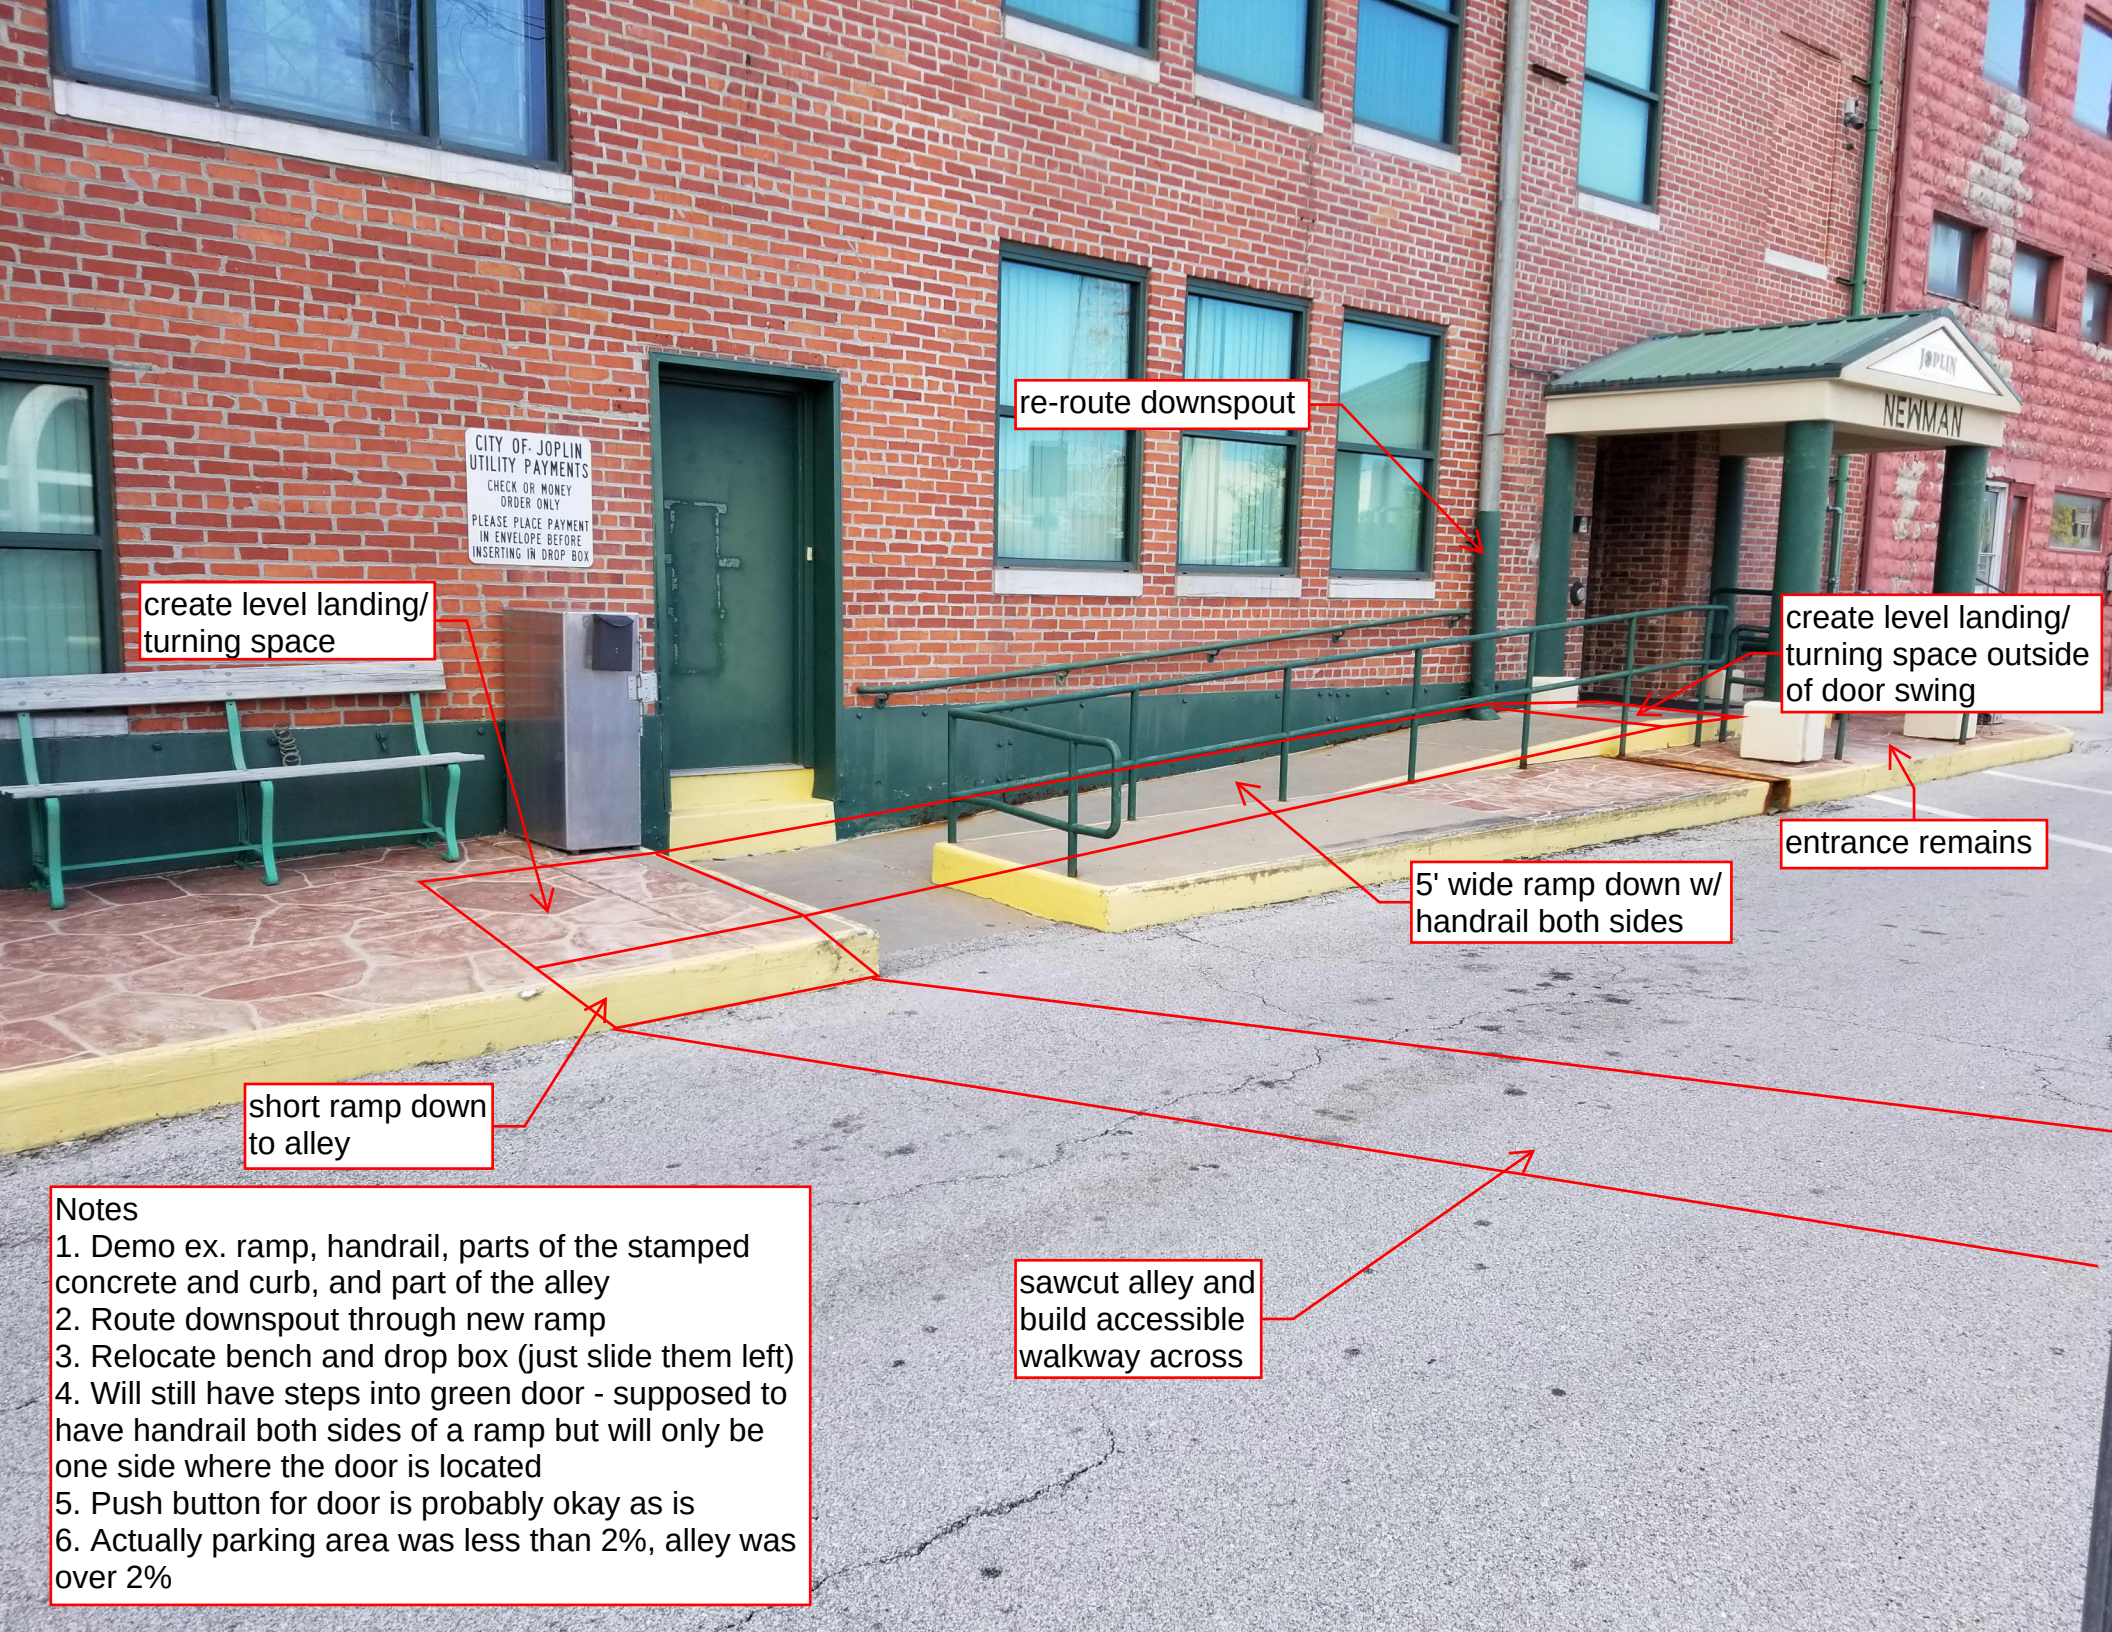
Notes
1. Demo ex. ramp, handrail, parts of the stamped concrete and curb, and part of the alley
2. Route downspout through new ramp
3. Relocate bench and drop box (just slide them left)
4. Will still have steps into green door - supposed to have handrail both sides of a ramp but will only be one side where the door is located
5. Push button for door is probably okay as is
6. Actually parking area was less than 2%, alley was over 2%
